SERVICE No. 759 BULLETIN

Subject: Exhaust muffler inspection and modification, Piper Part Number 12433-00, 12433-14, 12232-00.

Models Affected: PA-18 Series Super Cub

SPECIAL TOOLS FABRICATION DETAIL

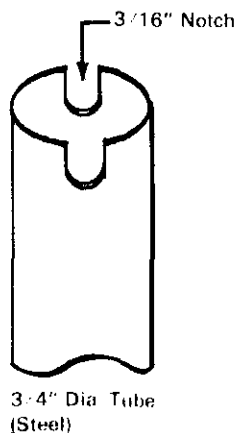
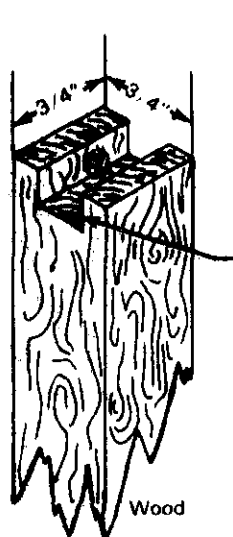
7. Remove shroud from muffler assembly and comply with AD 68-05-01.
8. Drill two 1/4 inch (.250) holes through the tailpipe as shown in the following sketch.
9. Install bale assembly, Piper Part Number 452 093 into tailpipe, curved end toward the muffler until contact is made with the internal baffle. The deflector must be installed so that the opposing legs cover the four holes that have been previously drilled.

Note: A 3/4 inch square x 18 inch long stick of wood or 3/4 inch diameter x 18 inch long metal tube may be fabricated into a special tool to twist the deflector if necessary after installation to locate two of the legs directly inside the 1/8 inch holes in the tailpipe. (See sketch).

10. Rosette weld by suitable method the bale through the four 1/4 inch holes in tailpipe.
11. Reassemble muffler assembly and reinstall on aircraft. Install exhaust system components and reconnect any lines, wire, and hoses that were removed. Attach engine properly and reinstall engine cowling that was removed.
12. Make appropriate log book entry stating compliance of this Service Release.

Rosette Weld (4 Required)

Bail Assembly (P/N 452 093)
(Should Be A Light Press Fit With The Four Rods Making Contact With Inside Wall Of Tailpipe. Slight Reshaping May Be Required)
